V2500 Propulsion System — Engine

ENGINE - POWERPLANT - - MODIFICATION OF OIL PRESSURE SWITCH PIPING
SUPPORT CLIPS

November 12, 1997

V2500-ENG-71-0004

FIGURE 1

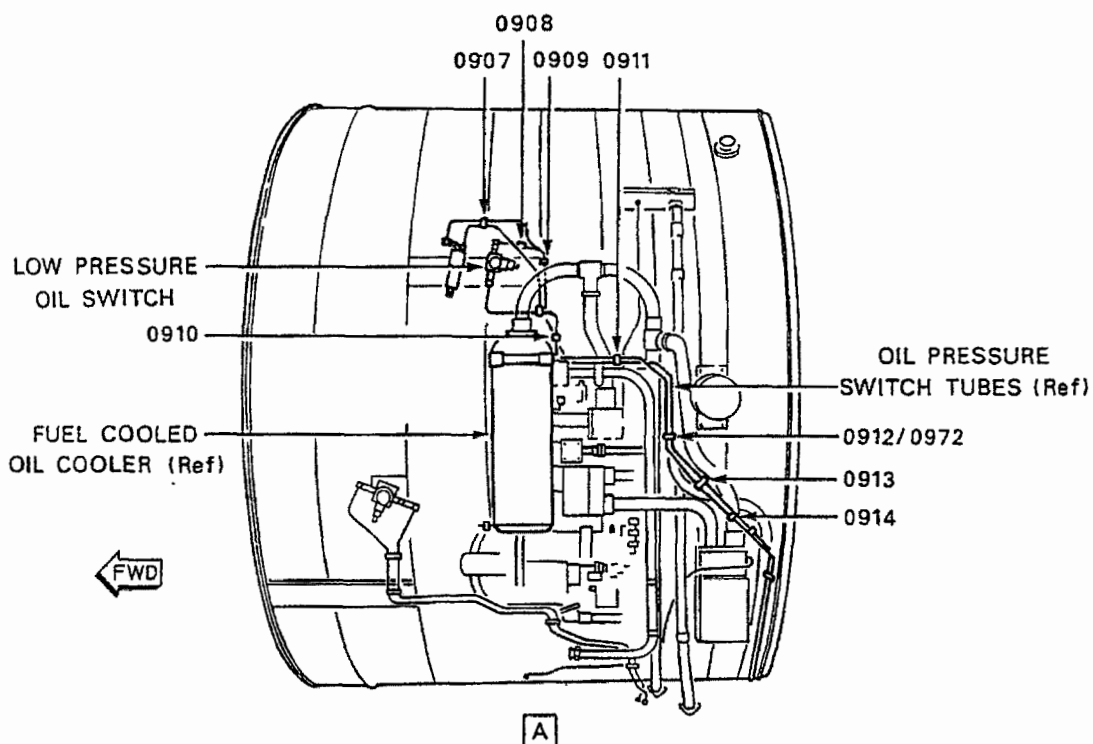
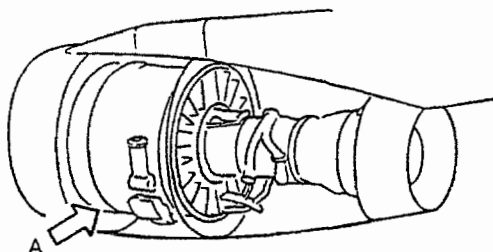
- (2) Remove two 400WSS-4 'P' clips, an AS21408 bolt, an AS20624 nut, and a SP154-D washer from clipping point CP0912. (Refer to Figures 1 and 3.) Keep clips for CP0972. Keep the remaining hardware for clipping point CP0973.

- (4) Put a 400WSS-14 'P' clip on the 5A8767 pipe, a 400WSS-4 'P' clip on the 740-5769 pipe, and a 400WSS-4 'P' clip on the 740-5757 pipe (local to clipping point CP0912) as shown to make clipping point CP0972. Attach the 'P' clips together with an AS21409 bolt, an AS20624 nut, and a SP154-D washer. Torque the bolt to 20-25 lbin (2.26-2.83 Nm).

NOTES: 1.CP0972 REPLACES CP0912
(REFER TO FIGURE 3)

FIGURE 2

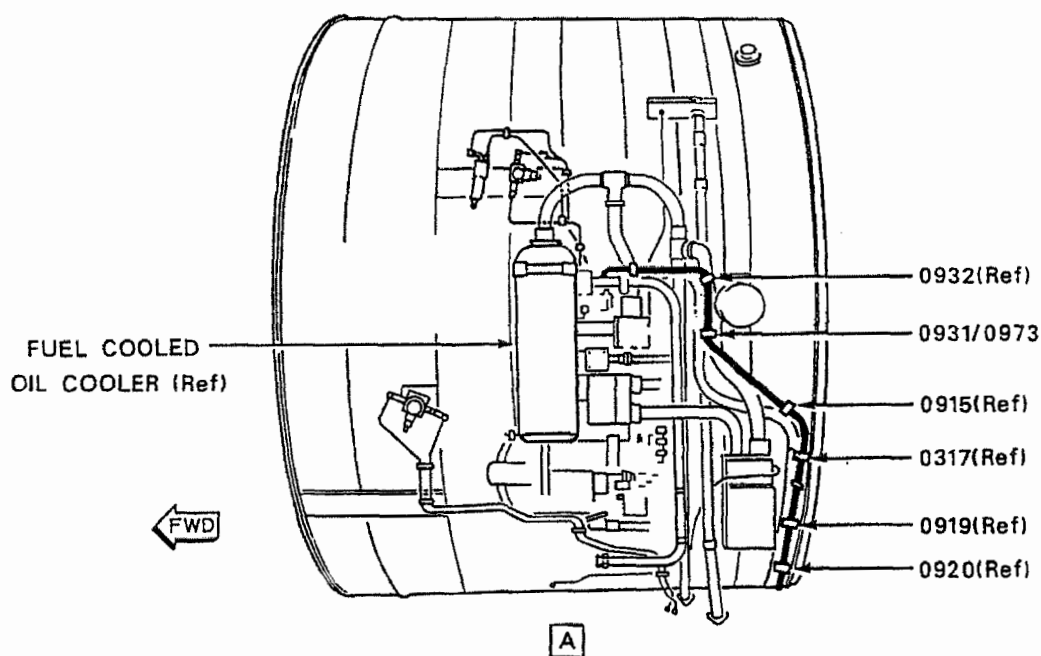
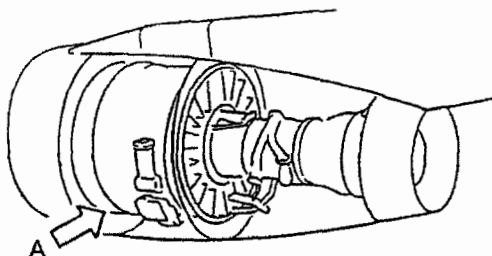
- (1) Remove an AS20624 nut, a SP154-D washer, and a 400WSS-4 'P' clip from clipping point CPO9331. (Refer to Figures 2 and 3.) Install the nut and washer back on CPO931. Torque the nut to 20-25 lbin (2.26-2.83 Nm). Keep the 400WSS-4 'P' clip for installation on the 740-5790 pipe.

- (3) Put a 400WSS-16 'P' clip on the 2A0649 pipe and the 400WSS-4 'P' clip on the 740-5790 pipe as shown (local to clipping point CPO931) to make clipping point CP0973. Attach the two clips together with an AS21408 bolt, an AS20624 nut, and a SP154-D washer kept from paragraph 2.B.(2). Torque the bolt to 20-25 lbin (2.26-2.83 Nm).

NOTE: CP0973 REPLACES CP0931
(REFER TO FIGURE 3)

MODIFICATION OF CLIPPING POINTS ON THE OIL PRESSURE SWITCH TUBES
FIGURE 3

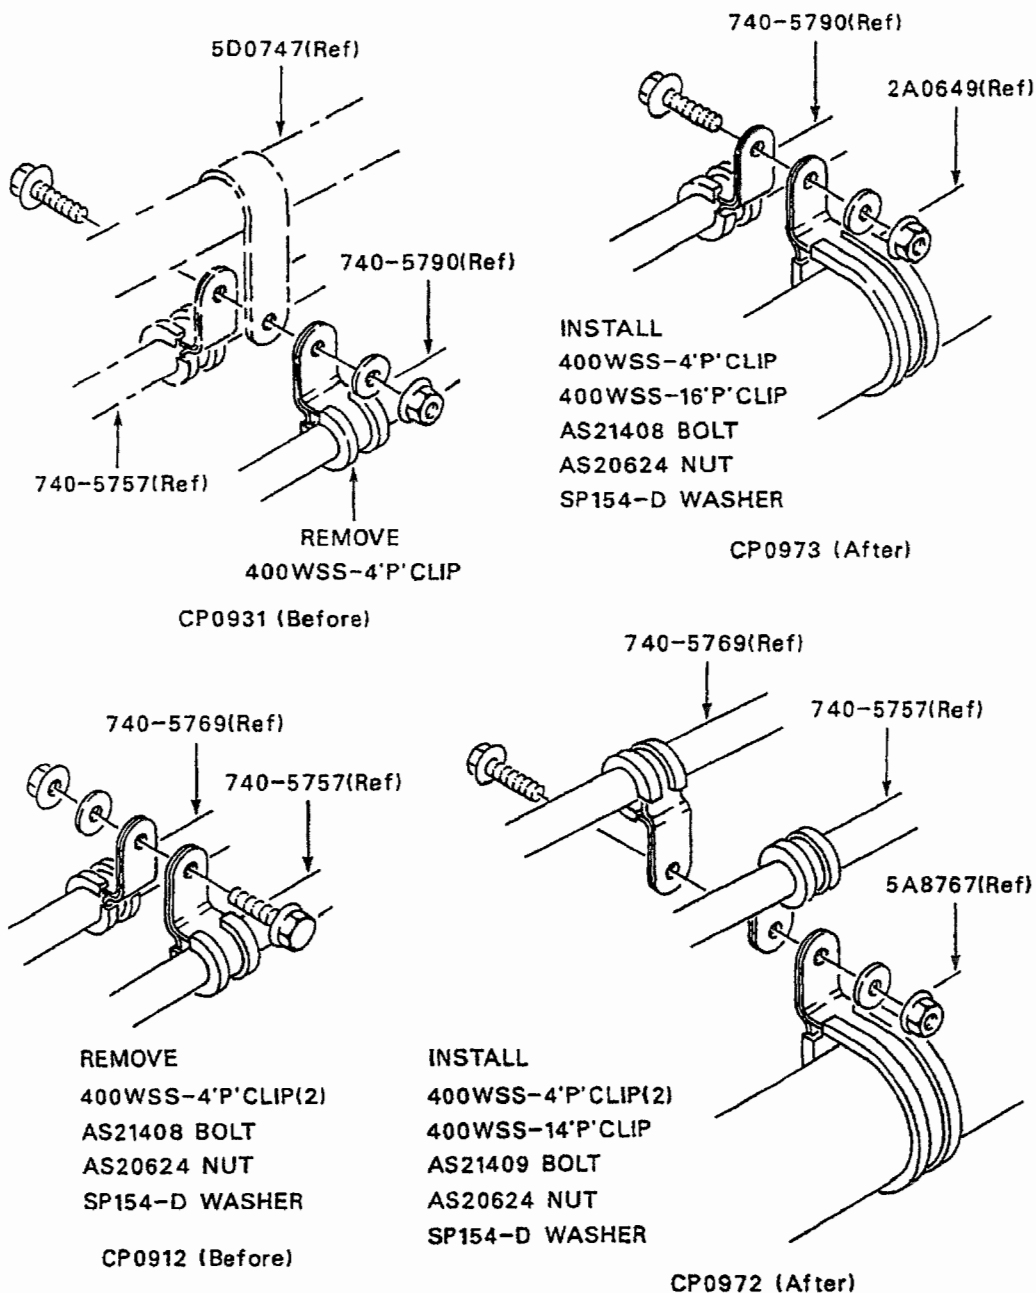
- (a) Pipe clips at two clipping positions on the oil pressure switch piping are disconnected. Two new clipping positions are introduced. (Two new 'P' clips installed on larger pipes, local to the old clipping positions) to which the pipe clips are connected. (Refer to figure 3.)
